Access Compliance Report

Public Rights-of-Way

(Curb Ramps)

Intersection ID: 2940	Main Street: DOWNFIELD_WOOD_DR	Cross Street: HARBURN_FOREST_DR	Location: SW
ADA ID: 3653D13E8A73	Ramp Type: PerpDiag	Initial Pass/Fail: Fail	Overall Compliance: No
Severity Score: 25			
Codes/Mitigation Info/Possible Solution		Field Measurements/Component Compliance

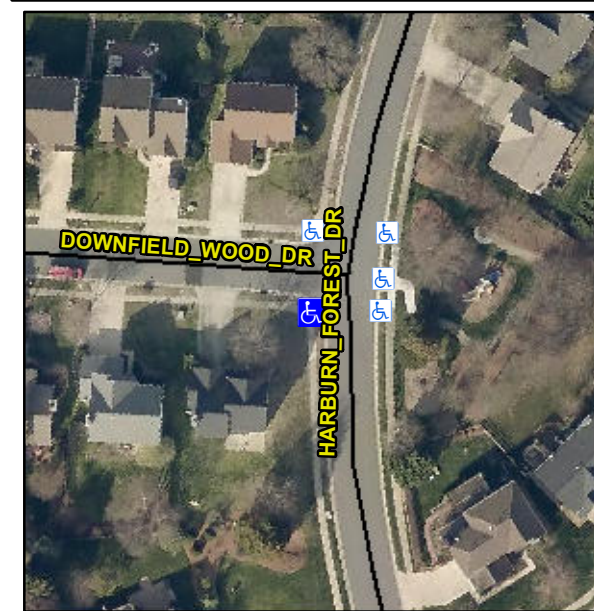
Not Found, R304.2.2

Compliance	Description	Data	Compliance	Description	Data
N/A	Ramp Length (in)	48.5	No	Ramp Slope (%)	13.9
Yes	Ramp Width (in)	104.0	Yes	Ramp XSlope (%)	0.3
N/A	Flare Type LT	N/A	N/A	Flare Type RT	N/A
N/A	Flare Slope LT (%)	N/A	N/A	Flare Slope RT (%)	N/A
N/A	Flare Traversable LT?	N/A	N/A	Flare Traversable RT?	N/A
N/A	Landing Length (in)	N/A	N/A	DWS Provided?	N/A
N/A	Landing Width (in)	N/A	N/A	DWS Contrast?	N/A
N/A	Landing Slope (%)	N/A	N/A	DWS Length (in)	N/A
N/A	Landing X Slope (%)	N/A	N/A	DWS Full Width?	N/A
N/A	Landing Curb? (Y/N)	N/A	N/A	DWS Offset (in)	N/A
N/A	Shared Landing?	N/A			
N/A	Gutter Ponding?	N/A	N/A	Gutter Slope (%)	N/A
N/A	Gutter Lip Ht (in)	N/A	N/A	Gutter X Slope (%)	N/A
N/A	Painted X Walk1?	No	N/A	Painted X Walk2?	No
	X Walk 1 Direction	To E		X Walk 2 Direction	To N
N/A	X Walk 1 Width (in)	N/A	N/A	X Walk 2 Width (in)	N/A
	X Walk 1 Slope (%)	6.3		X Walk 2 Slope (%)	4.1
	X Walk 1 X Slope (%)	1.9		X Walk 2 X Slope (%)	1.2

N/A	Ramp inside XWalk1?	N/A	N/A	Ramp inside XWalk2?	N/A
	Road Slope (%)	1.7	N/A	Clear Space?	N/A
	Road X Slope (%)	2.9	N/A	Clear Space to XWalk (in)	N/A
N/A	Any Obstructions?	N/A	N/A	Storm Grate/Utility Hazard?	N/A
	Obstruction Type			Storm Grate/Utility Type	
		N/A			N/A
			Yes	Surface Condition? (G/P)	Good

Remove & Replace Curb Ramp With Two New Directional Ramps or Equivalent.
